DRAWING NO. D212-664-147	TITLE CROSSTUBE ASS'Y (205 LOW FWD)	REV. B	DART AEROSPACE LTD ENGINEERING ORDER		D.E.O. NO. D212-664-147-B-1	SHEET NO. SHEET 1 OF 1	SCALE NTS
DRAWN <i>q2</i>	CHECKED <i>ASS</i>	MFG. APPR. <i>VB</i>	APPROVED <i>WJ</i>		DE APPR. <i>WJ</i>		
DATE 11.07.15	DATE 11.07.20	DATE 11.07.21	DATE 11/07/21		DATE 11.07.21

PURPOSE:

REPLACE MAGNOBOND WITH PROSEAL.

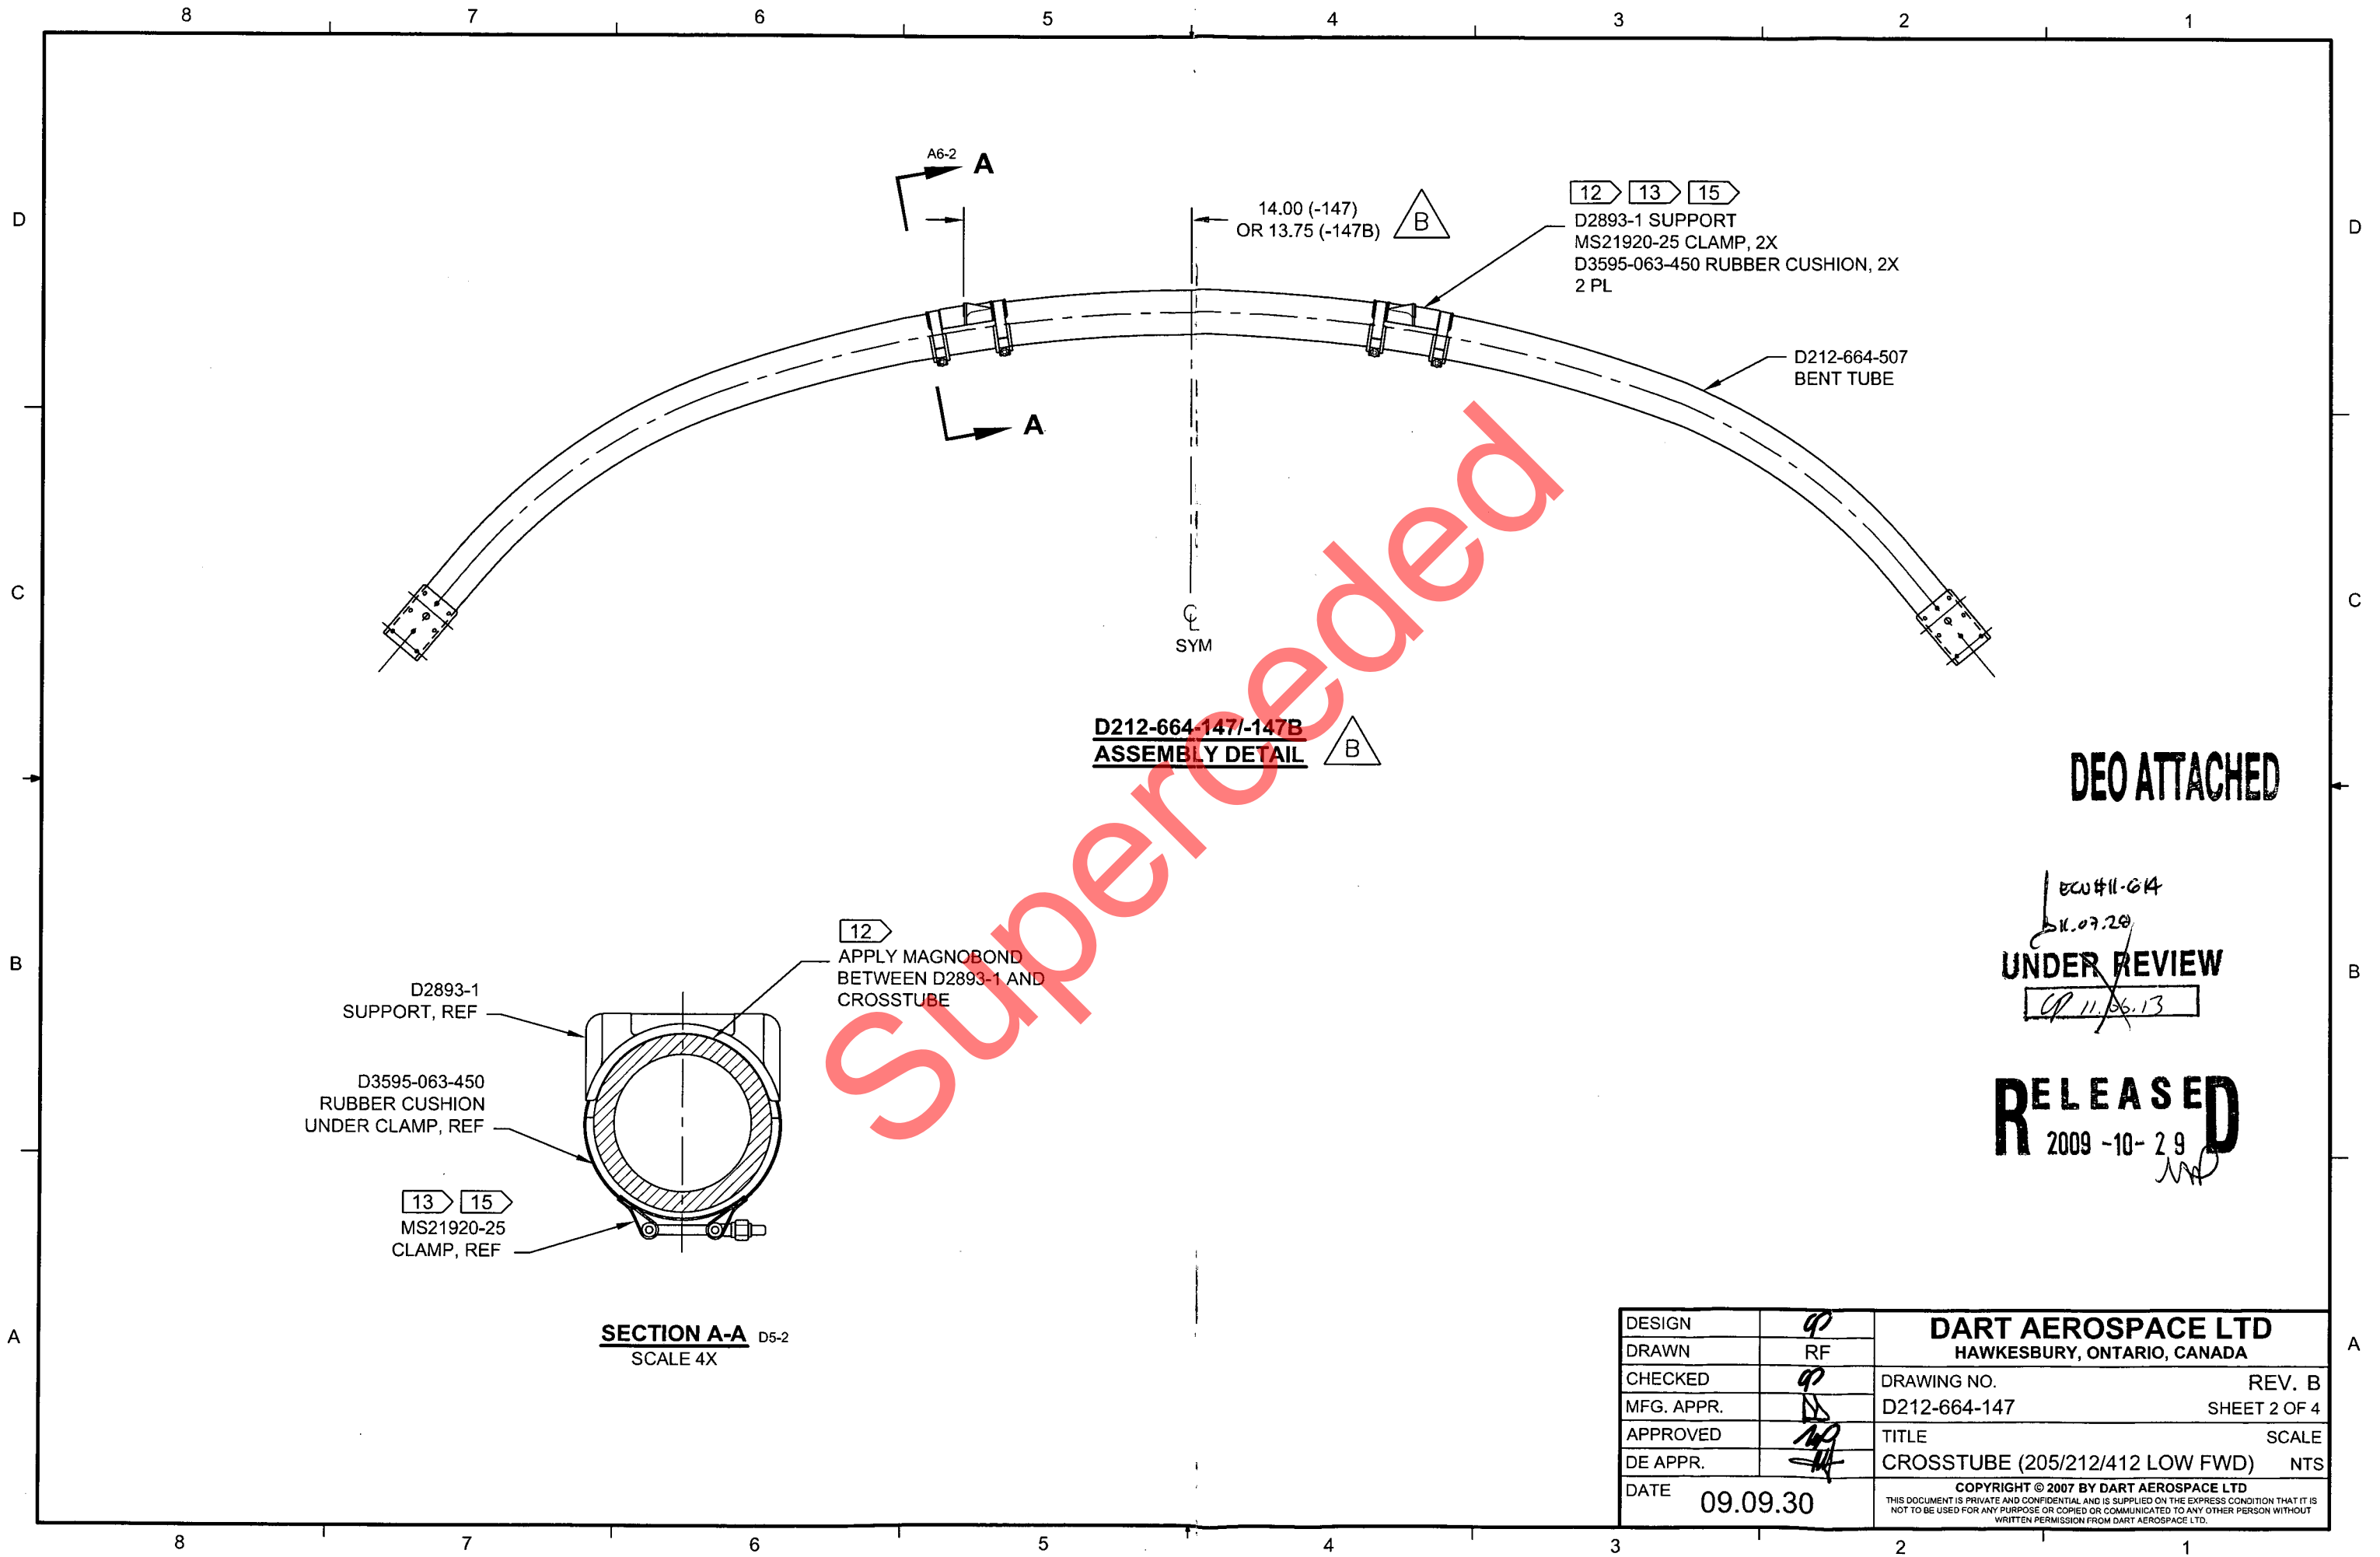
NOTE 12 & 15, SHEET 1 IS AMENDED AS FOLLOWS:

- 12) INSTALL D2893-1 SUPPORT USING 0.03" TO 0.06" THICK LAYER OF MAGNOBOND 6398 TO THE SURFACE OF D2893-1 THAT WILL BE IN CONTACT WITH THE CROSSTUBE PER QSI 015. LET CURE FOR 12 HOURS AFTER INSTALLATION AND PRIOR TO PACKAGING.
- 15) TORQUE CLAMPS 80 TO 100 IN-LB. ENSURE AT LEAST 1.5 THREADS SHOWING IN SAFETY AND THAT NUT HAS NOT BOTTOMED-OUT AFTER TORQUING.

Item	Qty -147	Qty -147B	Part Number	Description
9	A/R	A/R	PROSEAL 890 B-2	SEALANT, AMS-S-8802 CLASS B-2

- 12) TO INSTALL D2893-1 SUPPORT: ABRASE MATING SURFACE OF SUPPORT AND CROSSTUBE WITH 180-GRIT SANDPAPER AND REMOVE RESIDUE WITH MEK (OR EQUIVALENT). APPLY A 0.04" TO 0.07" THICK LAYER OF PROSEAL 890 CLASS B-2 (OR AMS-S-8802 CLASS B-2) SEALANT TO MATING SURFACE OF SUPPORT.
- 15) TORQUE CLAMPS 80 TO 100 IN-LB. ENSURE AT LEAST 1.5 THREADS SHOWING IN SAFETY AND THAT NUT HAS NOT BOTTOMED-OUT AFTER TORQUING. PRIOR TO PACKAGING, RE-CHECK TORQUE ON CLAMPS AFTER PROSEAL 890 SEALANT HAS CURED FOR 72 HOURS.
